▶ **FILE #:** 12-D-13-UR

▶ **APPLICANT:** WALNUT STREET GARAGE, LLC

▶ **PROPOSED USE:** Parking garage

▶ **APPROVE** the request for the multi-story parking garage as shown on the development plan subject to 7 conditions

1001 EAST 10TH AVENUE
 SUITE 201
 KNOXVILLE, TN 37917
 TEL: 865.524.8888
 FAX: 865.524.8889
 WWW.FULGHUMMACFARLANE.COM
 THIS PROJECT: 131034

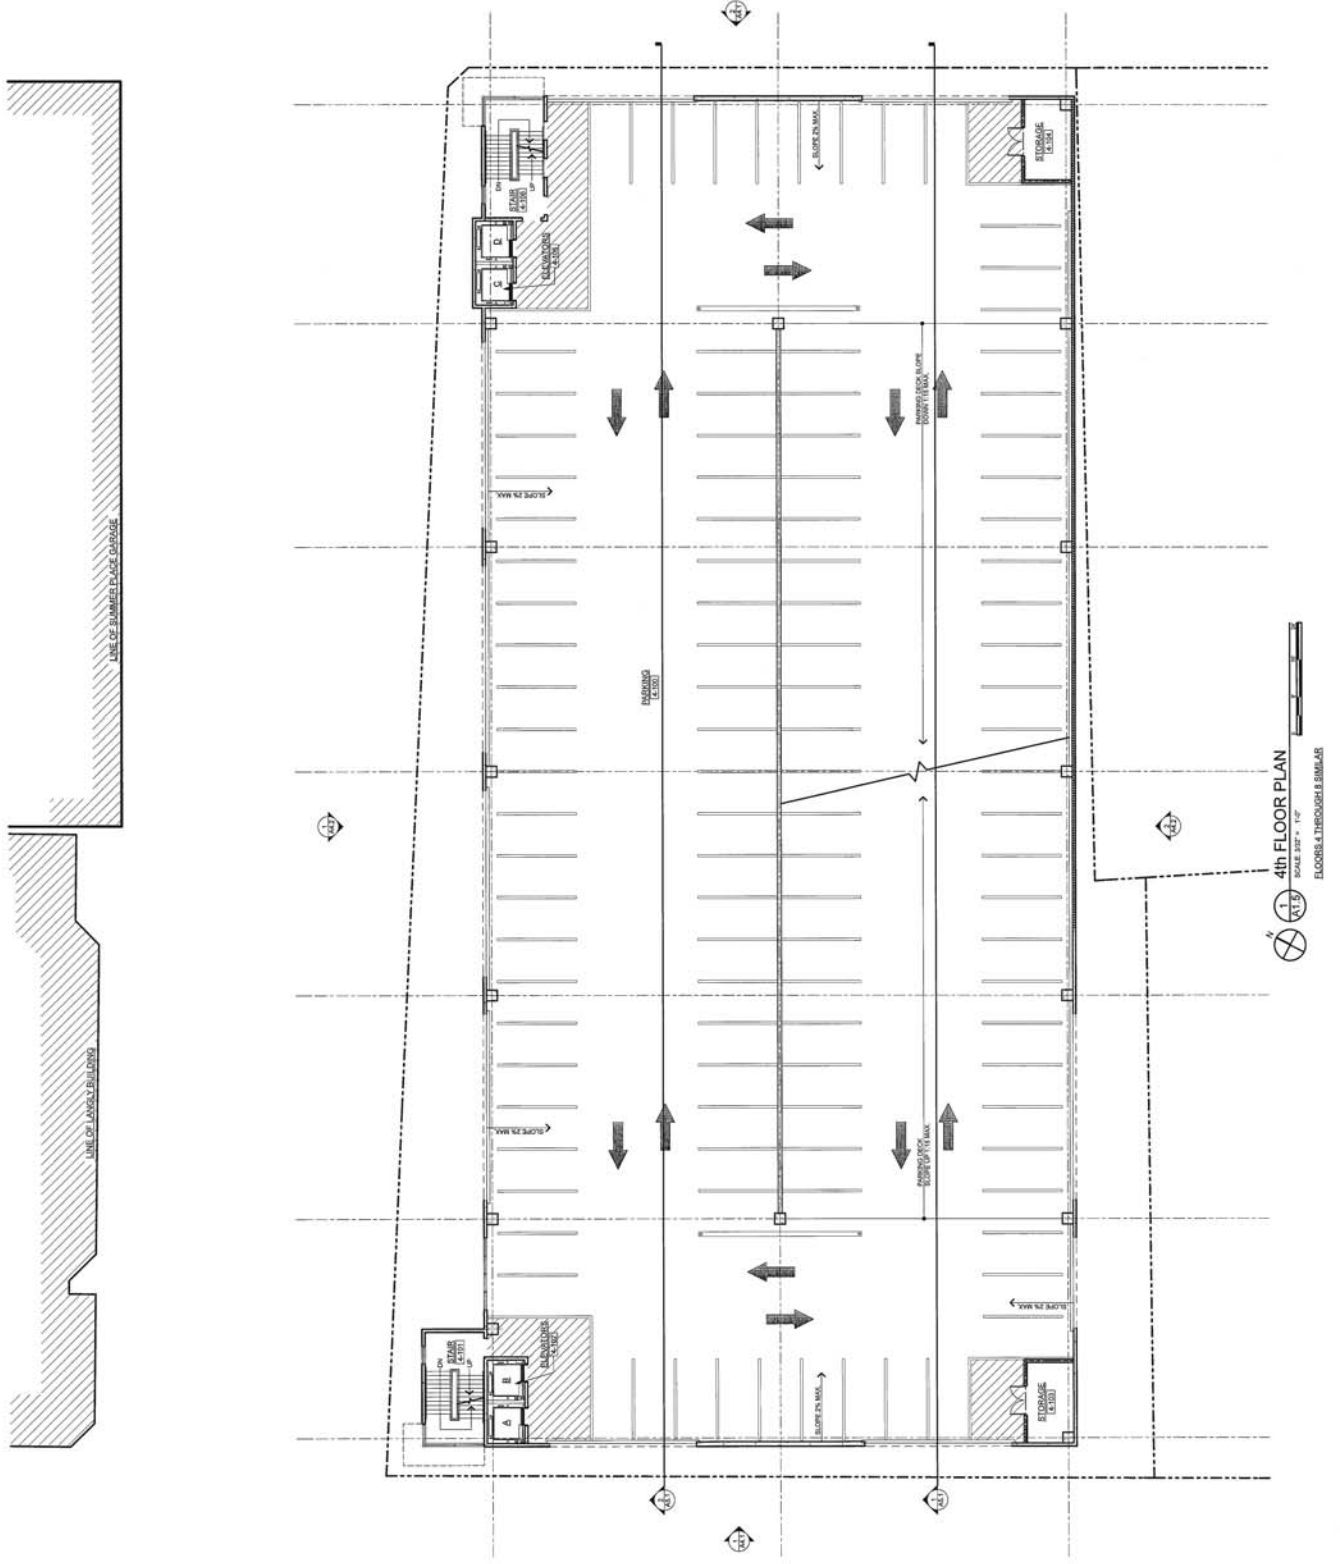
Staff is recommending that the parking layout on the first floor parking level be revised by removing 10 parking stalls on the south side of the two-way drive aisle that leads to the entrance/exit onto Walnut Street at the northeast corner of the building. This area shall be converted into a bypass lane to allow vehicles to get around vehicles stacking in the exit lane at the first exit so that they can continue to the other three exits. If the change is not made, as designed, the entrance/exit onto Walnut Street at the northeast corner of the building has the potential of holding up exiting traffic for approximately 968 of the 1071 parking stalls in the garage.

2. Meeting all other applicable requirements of the Knoxville Zoning Ordinance or obtaining any required variances.
3. Revising the parking layout on the first floor parking level by removing 10 parking stalls on the south side of the two-way drive aisle that leads to the entrance/exit onto Walnut Street at the northeast corner of the building. This area shall be converted into a bypass lane to allow vehicles to get around vehicles stacking in the exit lane at the first exit so that they can continue to the other three exits. Internal signage shall also identify that there are additional exits beyond the first exit. (See comments below.)
